General Clarifications of Facts within the Draft CAP

MEMORANDUM

This memo provides our comments on the groundwater monitoring frequency analysis based on BIOSCREEN model results for the Landsburg Mine Site (Site) by Golder Associates (consultant for the Site PLP Group) in a report dated October 13, 2009 (Golder, 2009). The intent of the BIOSCREEN evaluation was to assist in establishing the groundwater monitoring frequency for the long-term monitoring program as a component of the Site Cleanup Action Plan. Ecology provided input parameters, assumptions, and required output for the BIOSCREEN modeling in a memorandum dated August 7, 2009 (Ecology, 2009). We organize our comments by identifying Golder's independent assumptions in the modeling effort, summarizing Golder's BIOSCREEN results and analysis, providing a simple risk analysis of Golder's recommended monitoring frequencies, and providing our recommendations for alternative monitoring frequencies.

Figure 1: Calculated CUL Exceedance Breakthrough Times to Identified Compliance Wells

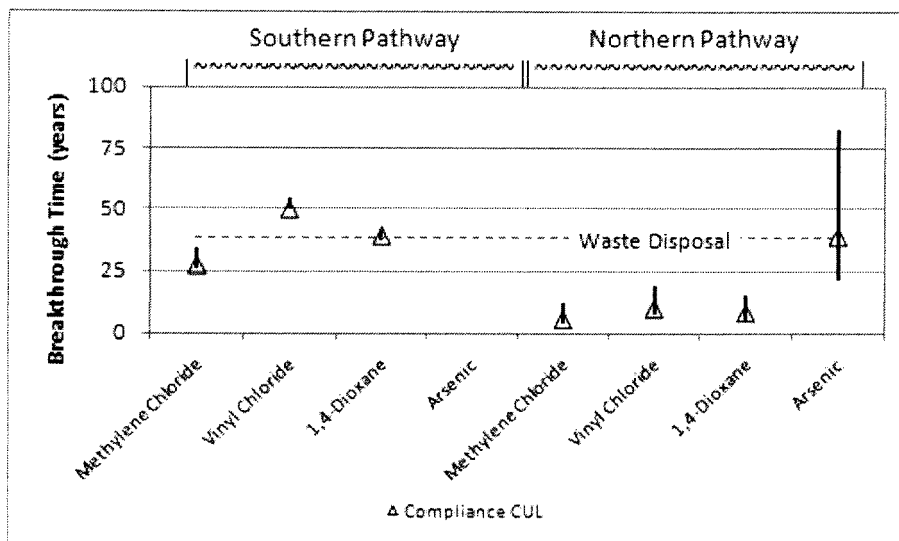
Figure 2 graphically compares Golder's calculated breakthrough times for MDLs at sentinel wells, MDLs at compliance wells, and exceedances of the CUL at compliance wells, based on the "medium-conservative" modeling scenario used to propose monitoring frequencies⁶. Detections at sentinel wells could provide advance warning of the migrating contaminant plume, assuming sentinel wells are completed within the plume pathway. Because CULs for the modeled VOCs are very low, detections at compliance wells are quickly followed by exceedances of CULs.

Figure 3: Differences in Breakthrough Times with Golder's Recommended Monitoring Frequencies

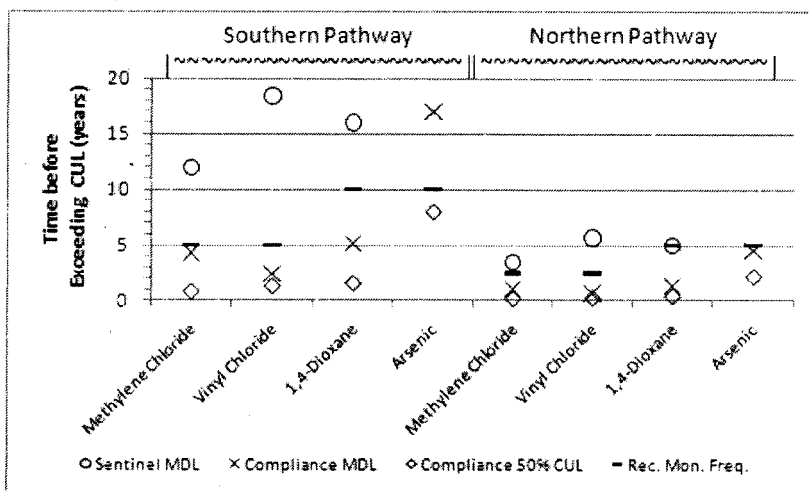
To help visualize the various modeling results, Figure 3 compares Golder's recommended monitoring frequencies (horizontal bars) with the modeled time differences between various levels of detection at sentinel and compliance wells versus CUL exceedances at compliance wells, for both pathways.

- The difference between detection (MDL) at a sentinel well and CUL exceedance at a compliance well is shown with a circle. Based on BIOSCREEN results, arsenic is detected at sentinel wells more than 20 years before it exceeds the CUL at compliance wells, so those circles are not shown on Figure 3.
- The difference between detection and CUL exceedances at a compliance well is shown with a cross.
- The difference between 50% CUL and the full CUL at a compliance well is shown with a diamond.

Figure 4: Risk Analysis Results of Recommended Monitoring Frequencies

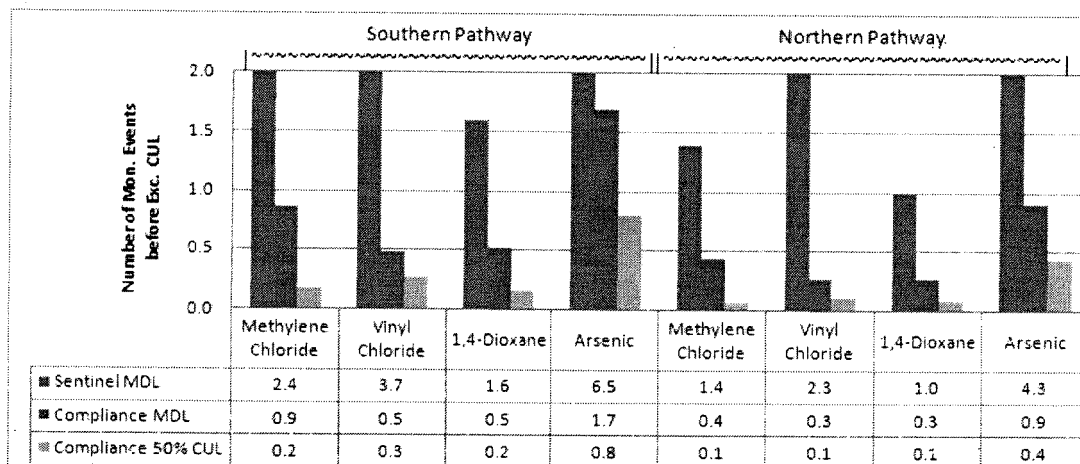
We conduct a simple risk analysis of Golder's recommended monitoring frequencies by dividing the monitoring frequency by the differences between various breakthrough times. This approach calculates the number of groundwater monitoring events before the CUL is exceeded at identified compliance wells, according to model breakthrough results. Figure 4 shows the results of the risk analysis.

If sentinel wells are positioned along a contaminant flow path, the recommended monitoring frequency would provide at least one monitoring event before the concentration exceeded a CUL at compliance wells also positioned along a contaminant flow path (blue bars in Figure 4). Given the lack of understanding of how groundwater moves within the mine workings, it is uncertain whether sentinel wells are appropriately positioned for contaminant detection. If sentinel wells miss the contaminant plume because they are not positioned along a

contaminant flow path, the chances of detecting a contaminant before the concentration exceeds the CUL at a compliance well are generally low (red bars on Figure 4). The chances are even lower of detecting a contaminant at or above 50% of the CUL before the concentration exceeds the CUL at a compliance well (green bars on Figure 4).

Cross-Section Showing Proposed Well Locations Landsburg Mine Site – Rogers Seam

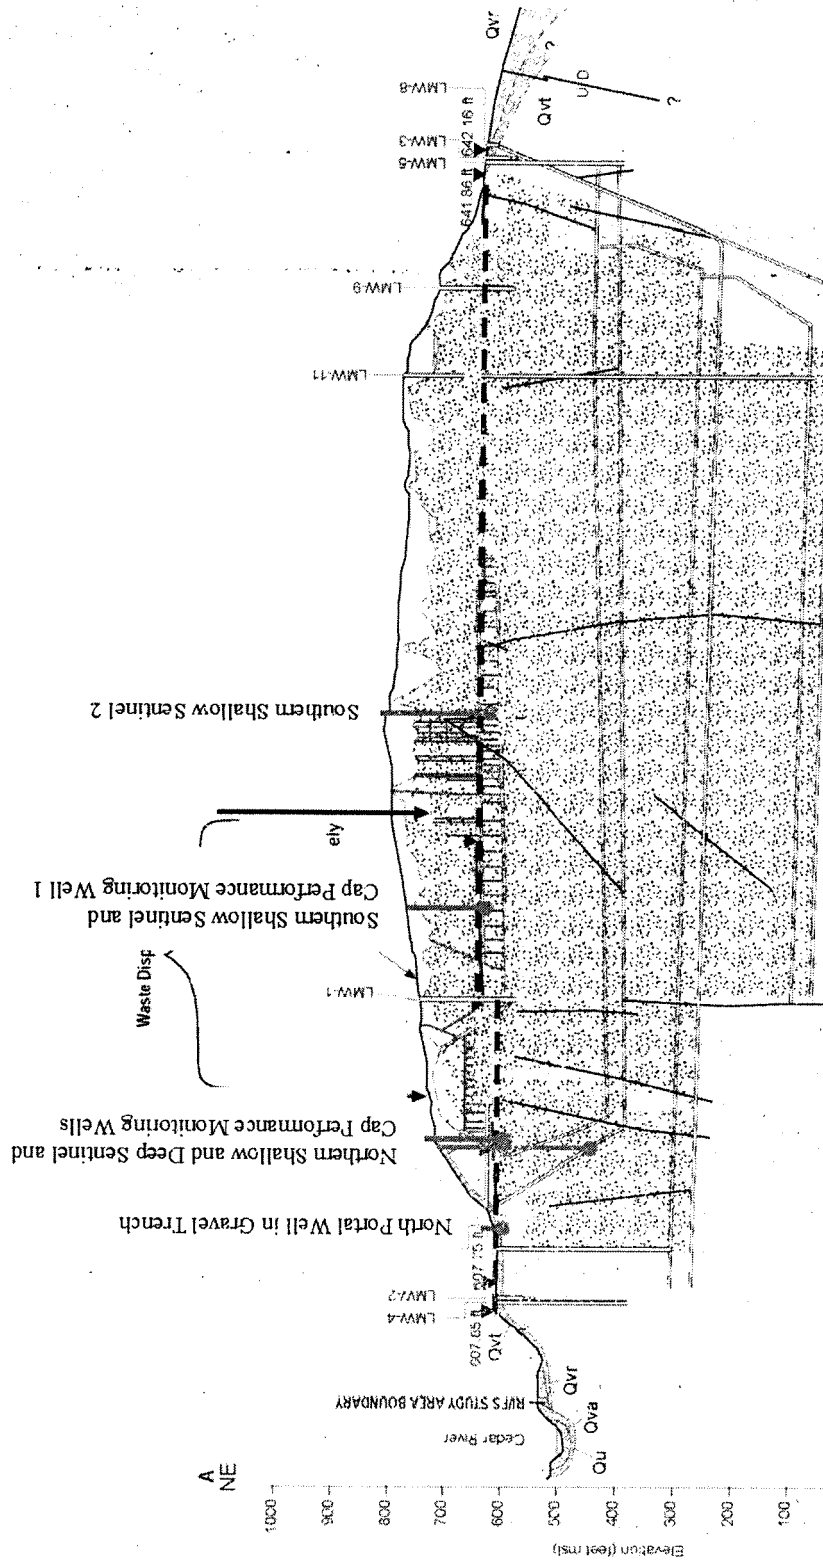
8. As we previously stated in our November 9 and December 11, 2009 comments, sentinel wells for the north portal need to be positioned upgradient (southwest) of the portal to be effective. The existing water level data from wells near the north portal (LMW-2, -4, -10) indicate upward gradients, suggesting upward groundwater flow toward the north portal, presumably preferentially following the inclined mine shaft as a permeable conduit. Groundwater at the north portal discharges subsurface via a gravel-filled trenchⁱ. As depicted on Figure 1 of Golder's December 4, 2009 memo, the two northern sentinel wells will not intercept the inclined shaft unless they would be drilled at a relatively steep angle to the southwest. If that is the plan, it should be clarified.

FIGURE 1
NORTH END SITE FEATURES
AND GROUNDWATER FLOW
LANDSBURG MINE SITE/NA

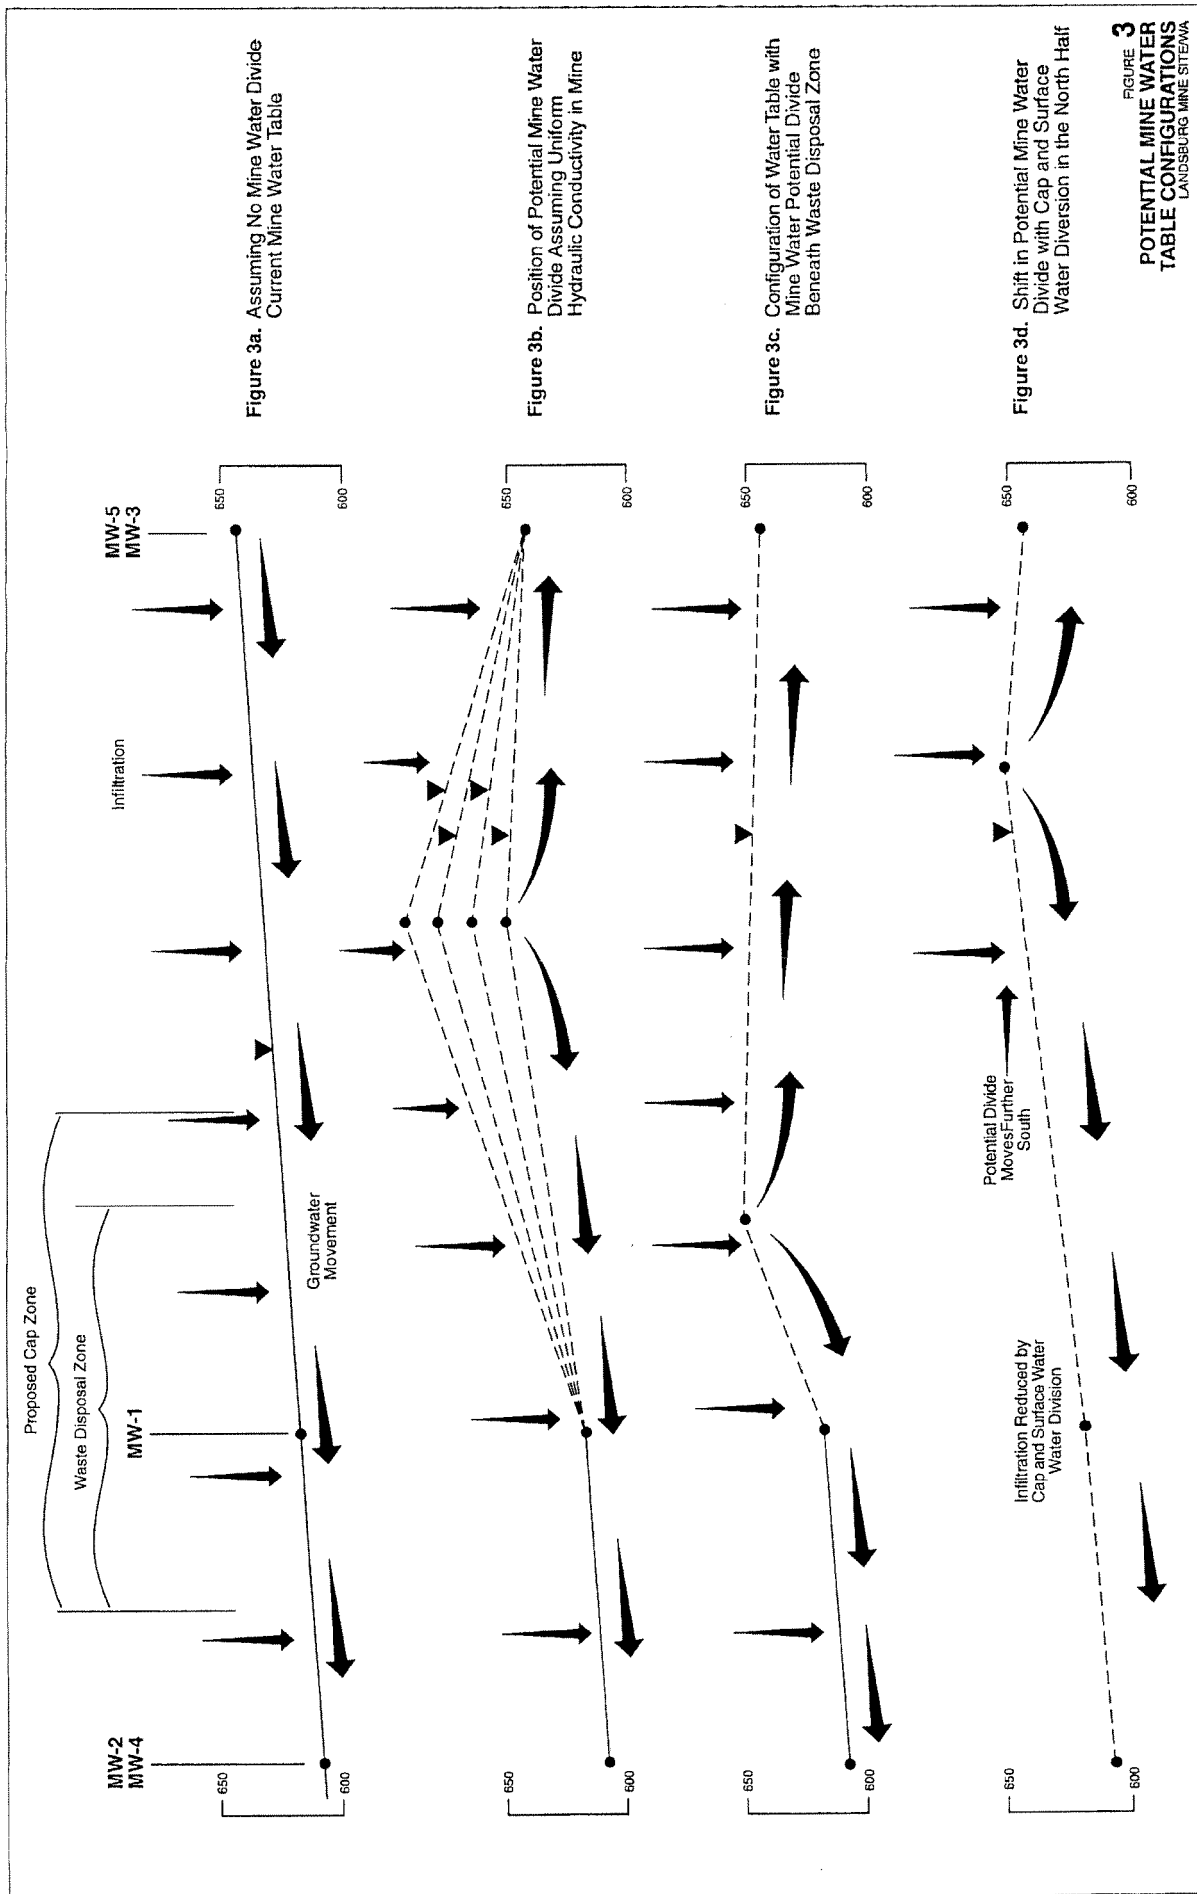
It is possible to conclude that no mine water actually discharges to Portal #3. Figure 3 illustrates potential mine water table configurations based on the observed water level measurements at monitor wells LMW - 1, 2, 3, 4 and 5. The most straight forward and obvious depiction is Figure 3a where the hydraulic gradient between all measured water levels is linear and all groundwater within the mine migrates from the south to the north (no mine water discharging at Portal #3). In this scenario, Portal #3 seep area is not only discharging groundwater from the surrounding gravel aquifer but is actually recharging water to the mine from the above gravel aquifer. Given the lower elevation and more substantial discharge zone of the Cedar River, the mine and coal seam could act as a conduit for transporting waters from the Portal #3 seep area north towards Portal #2. It is important to note the fact that the gradients north and south of LMW-1 are equal is further evidence of a consistent hydraulic gradient to the north.

The City's consultants have postulated that the indicated mine water divide may be positioned under the waste disposal trenches within the northern half of the site. Figure 3c illustrates the configuration of the water table necessary to accommodate this hypothesis that the mine water divide may be positioned under the waste disposal areas within the north half of the site. As can be seen in Figure 3c a very steep hydraulic gradient would have to exist between LMW-1 and the south end of the waste disposal zone (Trench 8 as identified in the RI/FS report). Hydrogeological conditions which could effect such a steep gradient would have to include extreme amounts of infiltration within Trench #8 and/or extremely low hydraulic conductivity of the mine aquifer just south of the rock bridge (below the Trench 8 zone). The contrast in either the infiltration or hydraulic conductivity in the Trench 8 zone are not indicated by site observations or mining records (see Figure 3-9 in RI/FS report). The mine had major horizontal drifts and collapsing/fragmentation of the coal seam throughout the north half of the mine. A

Surface drainage areas (see Figure 8-3 in RI/FS report) are not significantly different along the northern portions of the mine site to suggest extreme infiltration differences. In conclusion, a mine water table configuration as illustrated in Figure 3c is not supported by, nor expected based on available information.

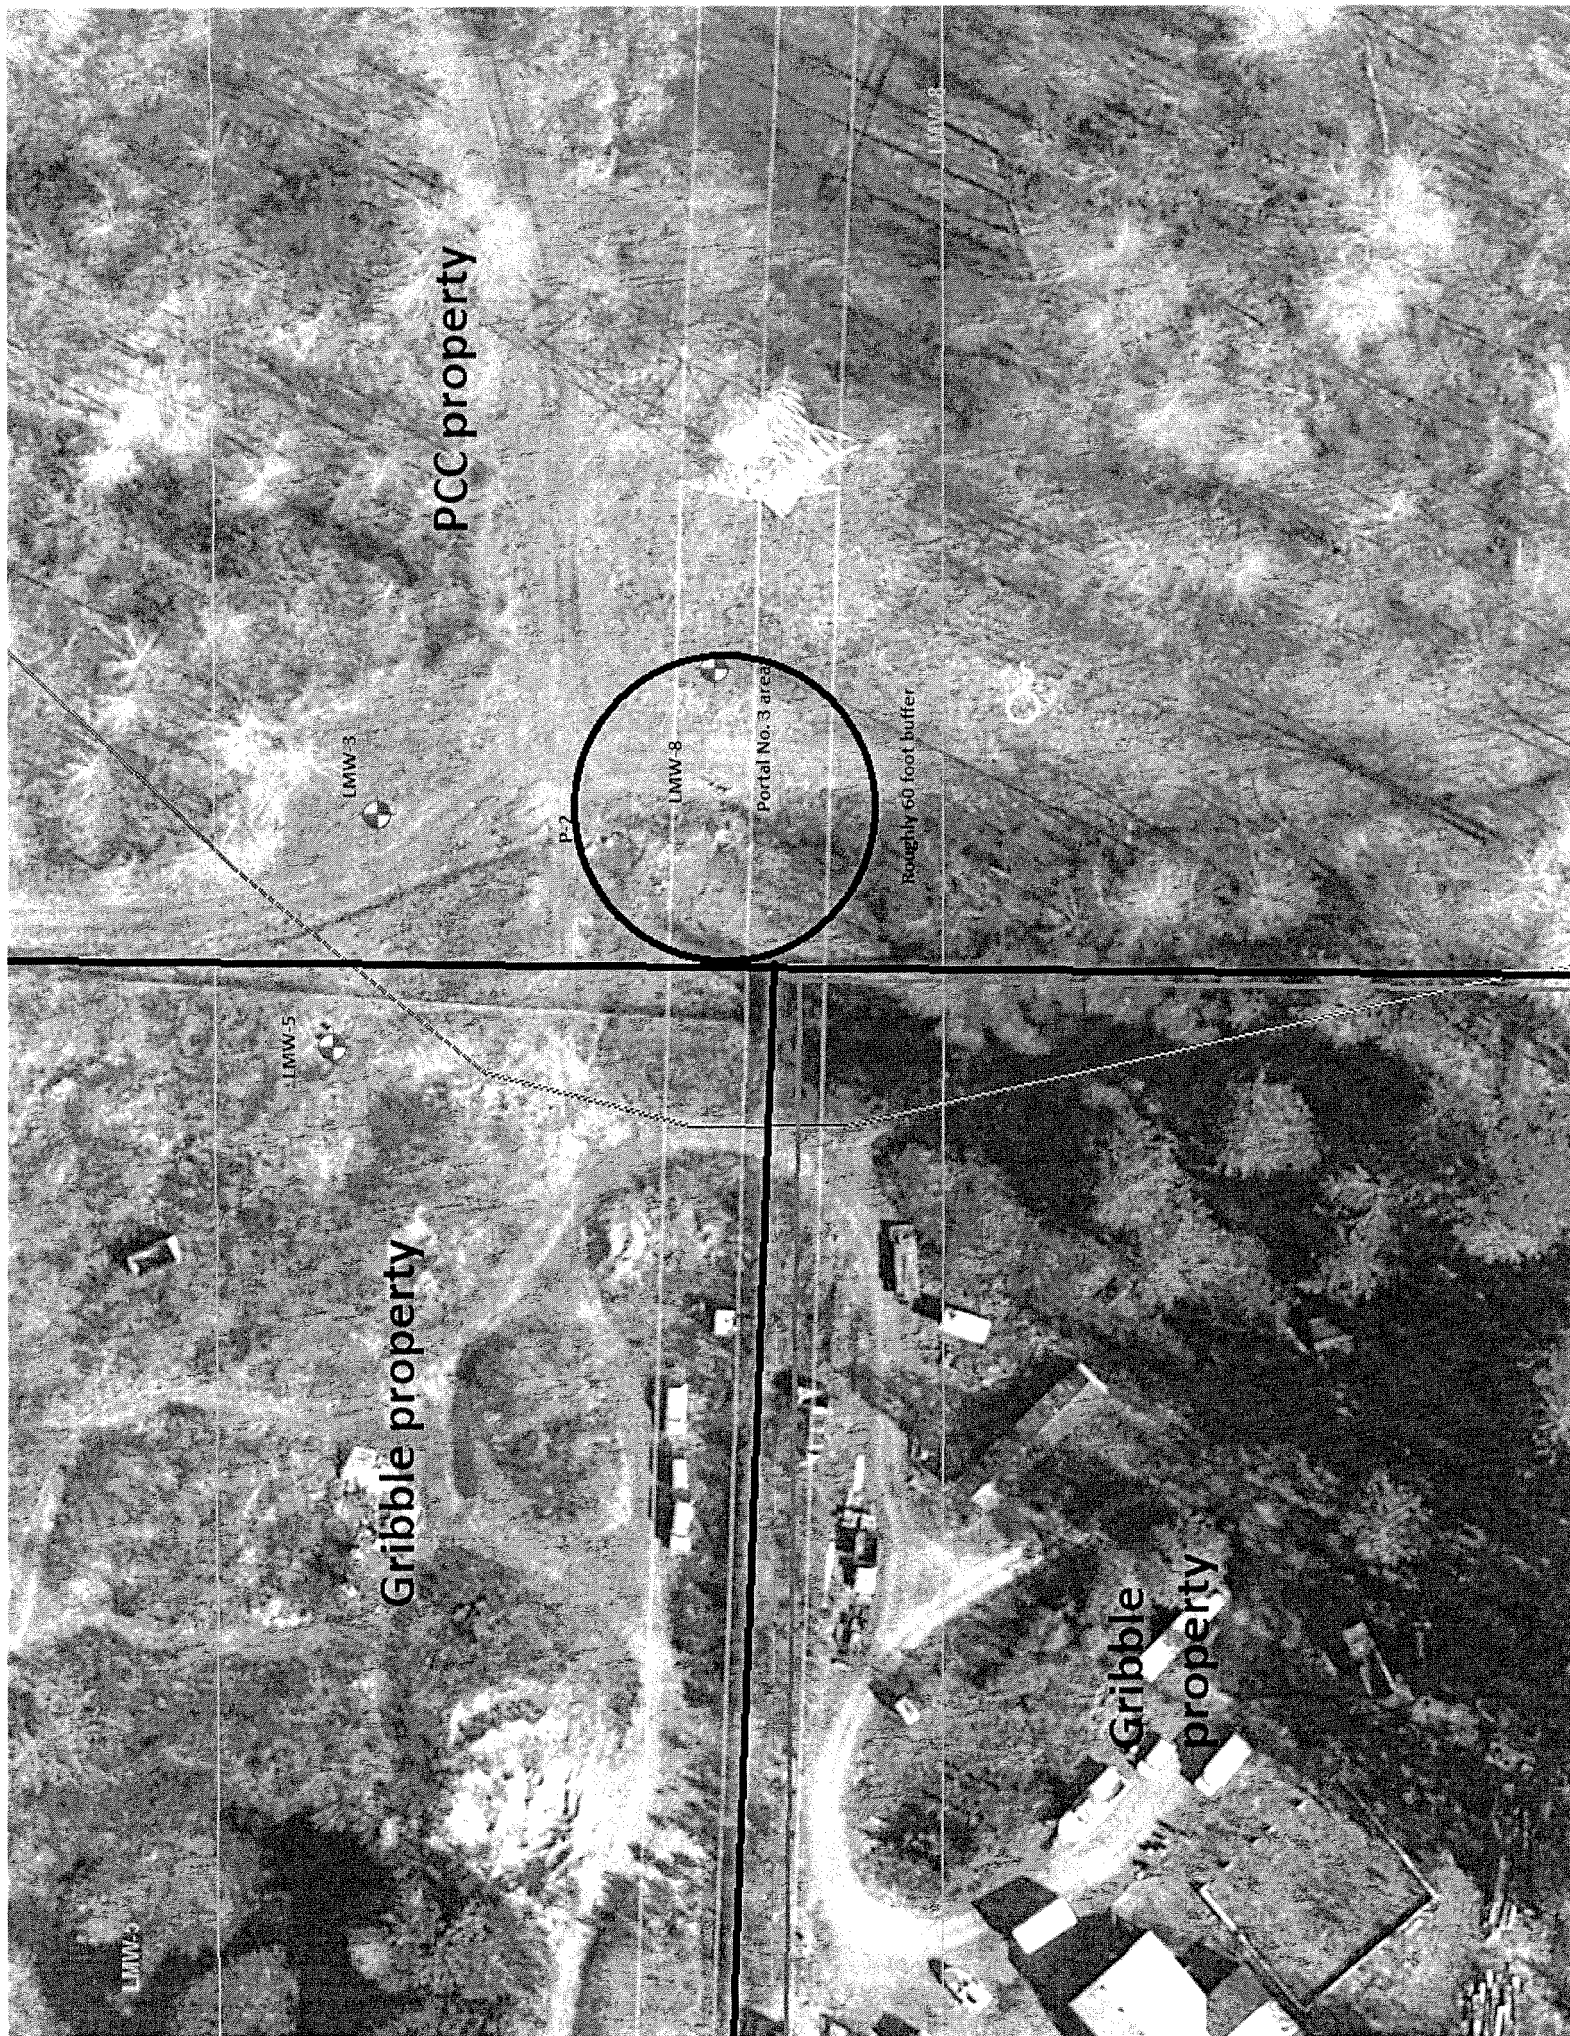
Our only edit is to suggest that the South Portal Buffer Area in Figure 4 to the PC&C EC be expanded slightly to the south. From past reports, water from the south portal is documented to manifest as a saturated (wet) seepage area or as surface water run-off depending on the time of the year. Measurements from these reports show that the southern edge of this saturated area is approximately 225 feet from LMW-3. The southern boundary of the buffer area in Figure 4 falls short of this known extent and should be further extended to adequately secure this area from redevelopment. Jerome has provided a revised figure showing our proposed revision to the buffer zone area (see attached).

Based on these actions, I think Jerome is inclined to scale back on his proposed southward expansion of the South Portal Buffer Area, as depicted on Figure 4 of the PC&C EC. Ecology could agree that the Buffer Area line would extend to the easement boundary for the power line, placing the southern margin a little more than half the distance between the PC&C proposed boundary and the Ecology proposed extended boundary.
